Jericho Wind, Inc. Jericho Wind Energy Centre

# **Natural Heritage Assessment and Environmental Impact Study Report Third Addendum**

**Project Number:** 60301207

Date: September, 2013

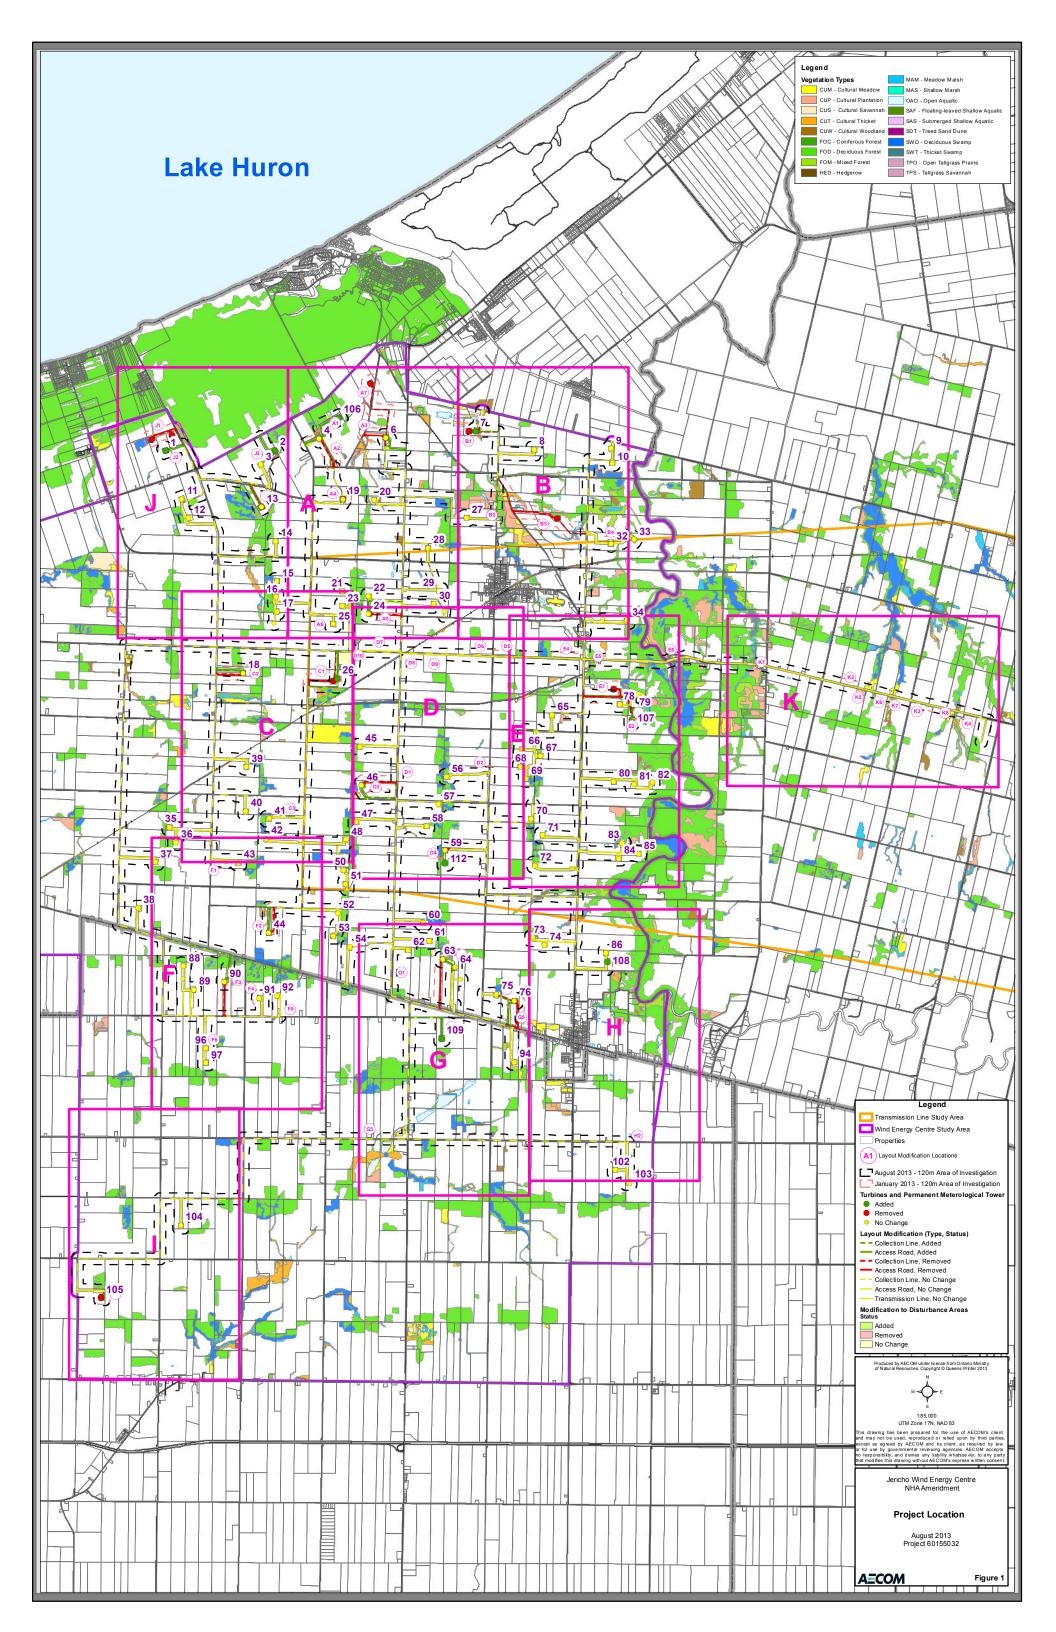
G1:	Addition of Turbine 62 construction disturbance area to the west and addition of collection line disturbance area in two locations in the Northville Road right-of-way.		<ul> <li>Collection line is within 120 m of Natural Area 103. Features within 120 m of this modification include:</li> <li>Woodland Feature WOD-082 (no change)</li> <li>Generalized Candidate Significant Wildlife Habitat: Bat Maternity Colony, Plant Species of Conservation Concern Habitat and Red-headed Woodpecker Habitat (no change).</li> </ul>	Figure 1G
G2:	Removal of the road and collection line to Turbine 63 and addition of road and collection line, extending west from Turbine 64 to Turbine 63.	Construction disturbance area modified to reduce or eliminate impacts to archaeological resources	<ul> <li>Access road is within 120 m of Natural Area 102. Features within 120 m of this modification include:</li> <li>Wetland Feature WET-063 (reduced to 20 m)</li> <li>Woodland Feature WOD-110 (reduced to 9 m)</li> <li>Candidate Significant Wildlife Habitat:</li> <li>Amphibian Woodland Breeding Habitat Feature AWO-04 (reduced to 9 m)</li> <li>Generalized Candidate Significant Wildlife Habitat: Mature Forest Stand, Plant Species of Conservation Concern Habitat and Red-headed Woodpecker Habitat (reduced to 9 m)</li> </ul>	Figure 1G

Modification ID	Type of Modification	Feature(s) Potentially Affected by Proposed Modification (Change in Minimum Distance to Project Location)	Мар
G3:	Removal of collection line construction disturbance area north of Birnam Line.	Infrastructure or construction disturbance area added or changed to optimize project design/ constructability	<ul> <li>Collection line remains within 120 m of Natural Area 42. Features within 120 m of this modification include:</li> <li>Woodland Feature WOD-047 (no change)</li> <li>Generalized Candidate Significant Wildlife Habitat: Bat Maternity Colony, Raptor Wintering Area, Mature Forest Stand, Rare Vegetation Community, Amphibian Woodland Breeding Habitat, Plant Species of Conservation Concern Habitat, Red-headed Woodpecker Habitat and Insect Species of Conservation Concern Habitat (no change)</li> </ul>	
G4:	Relocation of collection line between Turbines 76 and 75 20 m to the south.	Construction disturbance area modified to reduce or eliminate impacts to archaeological resources	<ul> <li>Collection line is within 120 m of Natural Area 97. Features within 120 m of this modification include:</li> <li>Wetland Feature WET-025 (increased to 22 m)</li> <li>Woodland Feature WOD-084 (increased to 22 m)</li> <li>Candidate Significant Wildlife Habitat:</li> <li>Bat Maternity Colony Feature BMA-097 (increased to 22 m)</li> <li>Generalized Candidate Significant Wildlife Habitat: Plant Species of Conservation Concern Habitat and Red-headed Woodpecker Habitat (increased to 22 m)</li> </ul>	Figure 1G

G5:	Relocation of Turbine 76 access road and collection line 134 m to the west.	Construction disturbance area modified to reduce or eliminate impacts to archaeological resources	<ul> <li>Access road and collection line are within 120 m of Natural Area 516. Features within 120 m of this modification include:</li> <li>Generalized Candidate Significant Wildlife Habitat: Turtle Wintering Area (reduced to 1 m) Access road and collection line are within 120 m of Natural Area 85. Features within 120 m of this modification include:</li> <li>Woodland Feature WOD-077 (no change)</li> <li>Generalized Candidate Significant Wildlife Habitat: Plant Species of Conservation Concern Habitat (no change)</li> </ul>	Figure 1G
G6:	Addition of Turbine 109 and associated construction disturbance area, access road and collection line; addition of collection line in Hickory Creek Line right-of-way.	Infrastructure or construction disturbance area added or changed to optimize project design/ constructability	None (no Natural Areas are within 120 m of this modification).	Figure 1G

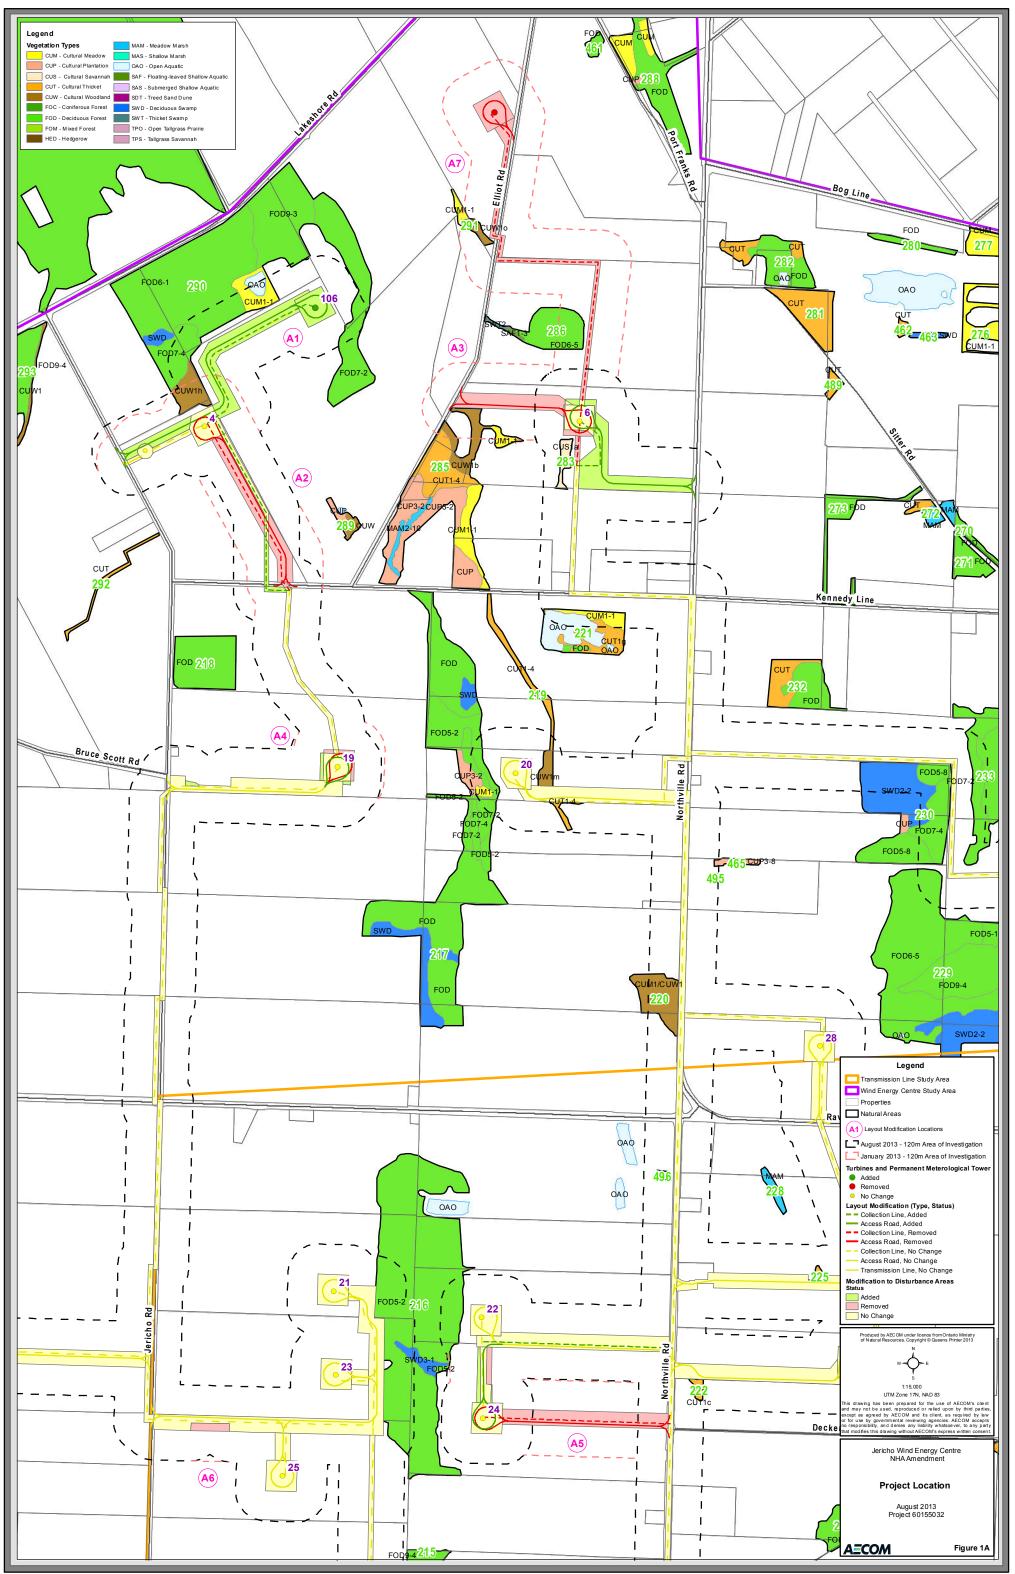
H1:	Addition of Turbine 108 and associated construction disturbance area.	Infrastructure or construction disturbance area added or changed to optimize project design/ constructability	None (no Natural Areas are within 120 m of this modification).	Figure 1H
H2:	Relocation of collection line from private property to Birnam Line right-of-way.	Construction disturbance area modified to reduce or eliminate impacts to archaeological resources	None (no Natural Areas are within 120 m of this modification).	Figure 1H

11:	Relocation of Turbine 105 20 m to the south and addition of construction disturbance area.	Infrastructure or construction disturbance area added or changed to optimize project design/ constructability	None (no Natural Areas are within 120 m of this modification).	Figure 1I
J1:	Removal of Turbine 2 and associated access road and collection line.	Turbine and associated infrastructure removed	<ul> <li>Removed Turbine 2, and associated access road and collection line are within 120 m of Natural Area 493. Features within 120 m of this modification include:</li> <li>Woodland Feature WOD-278 (no change)</li> <li>Confirmed Significant Wildlife Habitat:</li> <li>Deer Winter Congregation Area Feature DWC-01 (no change)</li> <li>Generalized Candidate Significant Wildlife Habitat: Bat Maternity Colony, Woodland Raptor Nesting Habitat, Plant Species of Conservation Concern Habitat, Woodland Area-Sensitive Bird Breeding Habitat and Red-headed Woodpecker Habitat (no change)</li> </ul>	Figure 1J

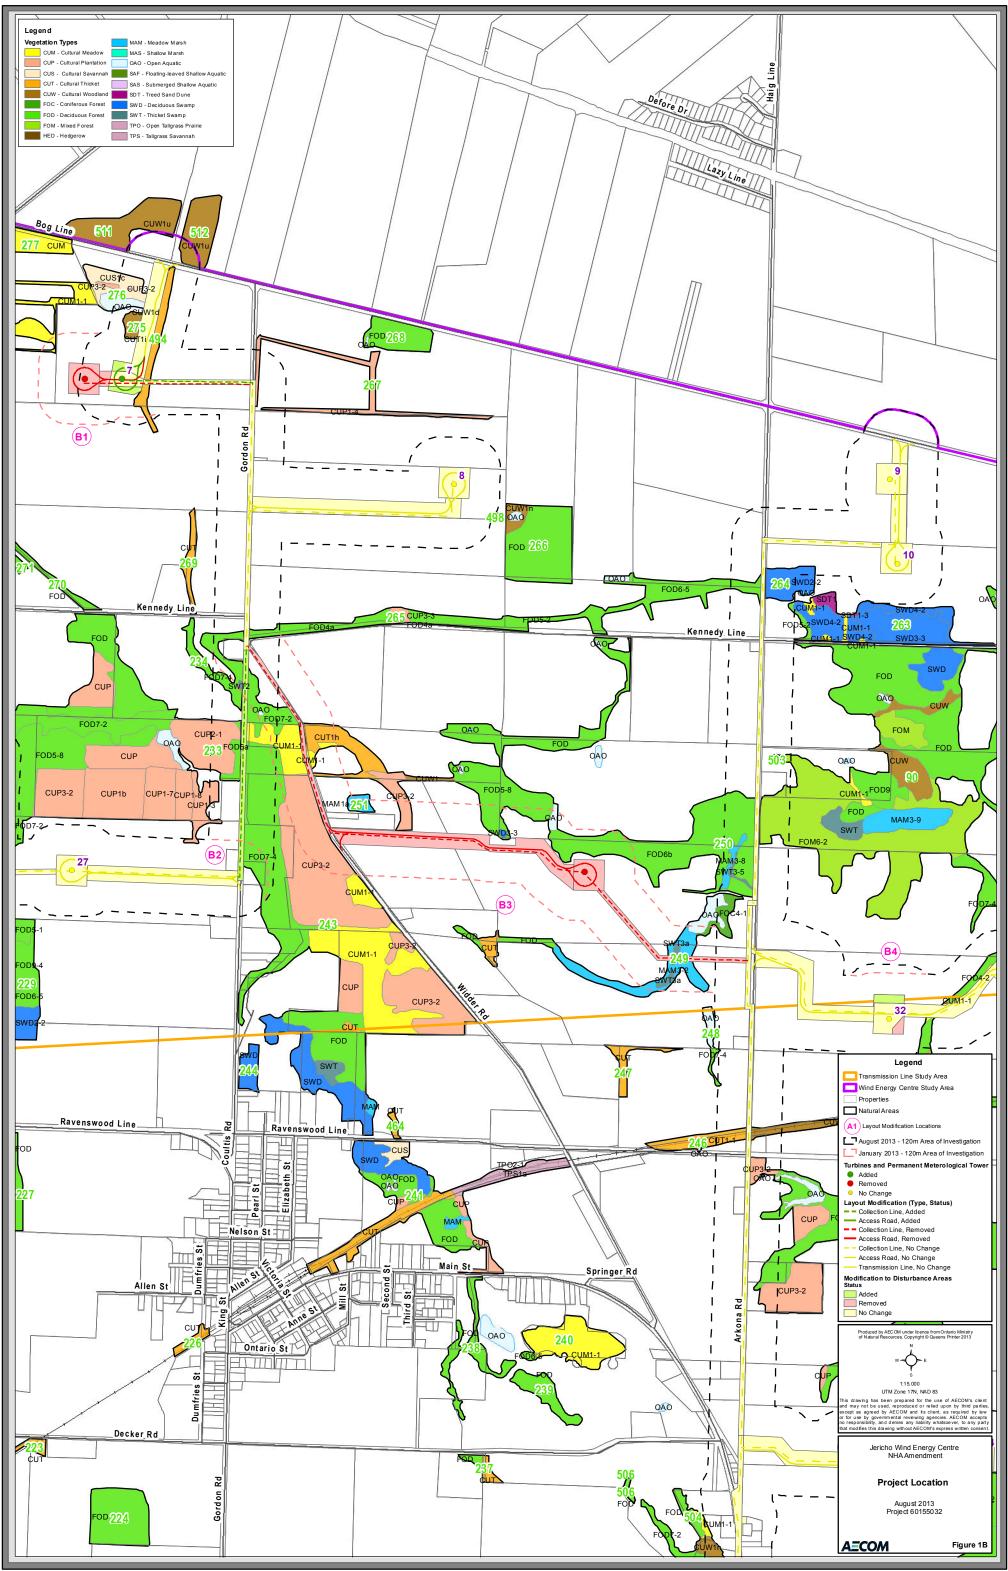
Modification ID	Type of Modification	Feature(s) Potentially Affected by Proposed Modification (Change in Minimum Distance to Project Location)	Мар
J2:	Relocation of Turbine 1 and associated construction disturbance area, access road and collection line.	Infrastructure or construction disturbance area added or changed to optimize project design/ constructability	<ul> <li>Removed Turbine 1, and associated access road and collection line are within 120 m of Natural Area 298. Features within 120 m of this modification include:</li> <li>Wetland Feature WET-046 (increased to &gt;120 m)</li> <li>Candidate Significant Wildlife Habitat: <ul> <li>Turtle Nesting Habitat Feature (TNH-02) (increased to &gt;120 m)</li> </ul> </li> <li>Natural Area 297 is no longer within 120 m of the Project Location. Features within this Natural Area include: <ul> <li>Wetland Feature WET-046 (increased to &gt;120 m)</li> </ul> </li> <li>Natural Area 297 is no longer within 120 m of the Project Location. Features within this Natural Area include: <ul> <li>Wetland Feature WET-046 (increased to &gt;120 m)</li> </ul> </li> <li>Voodland Feature WOD-261 (increased to &gt;120 m)</li> <li>Candidate Significant Wildlife Habitat: <ul> <li>Bat Maternity Colony Feature (BMA-297) (increased to &gt;120 m)</li> </ul> </li> <li>Generalized Candidate Significant Wildlife Habitat: Plant Species of Conservation Concern Habitat (increased to &gt;120 m)</li> </ul> <li>Turbine 1 and associated construction disturbance area, access road and collection line are within 120 m of a portion of Natural Area 298 that was not previously described in the approved NHA and EIS. Features within 120 m of this modification are described in this NHA Addendum.</li>	Figure 1J

<ul> <li>120 m of Natural Area 493. Features within 1200 m of this modification include:</li> <li>Woodland Feature WOD-278 (no change)</li> <li>Confirmed Significant Wildlife Habitat:</li> <li>Deer Winter Congregation Area Feature DWC-01 (no change)</li> <li>Generalized Candidate Significant Wildlife Habitat: Bat Maternity Colony, Woodland Raptor Nesting Habitat, Plant Species of Conservation Concern Habitat, Woodland Area-Sensitive Bird Breeding Habitat and Red-headed Woodpecker Habitat (no change)</li> </ul>	
J3:	Addition of Turbine 2 and associated construction disturbance area, access road and collection line.	Infrastructure or construction disturbance area added or changed to optimize project design/ constructability	Addition of Turbine 2 and associated construction disturbance area, access road and collection line are within 120 m of a portion of Natural Area 293 that was not previously described in the approved NHA and EIS. Features within 120 m of this modification are described in this NHA Addendum.	Figure 1J

J4:		Construction disturbance area modified to reduce or eliminate impacts to archaeological resources	<ul> <li>Turbine construction disturbance area remains within 120 m of Natural Area 214. Features within 120 m of this modifications include:</li> <li>Wetland Feature WET-044 (increased to 41 m)</li> <li>Woodland Feature WOD-245 (no change)</li> <li>Candidate Significant Wildlife Habitat: <ul> <li>Bat Maternity Colony Feature BMA-214 (no change)</li> </ul> </li> <li>Generalized Candidate Significant Wildlife Habitat: Plant Species of Conservation Concern Habitat and Red-headed Woodpecker Habitat (no change)</li> </ul>	Figure 1J
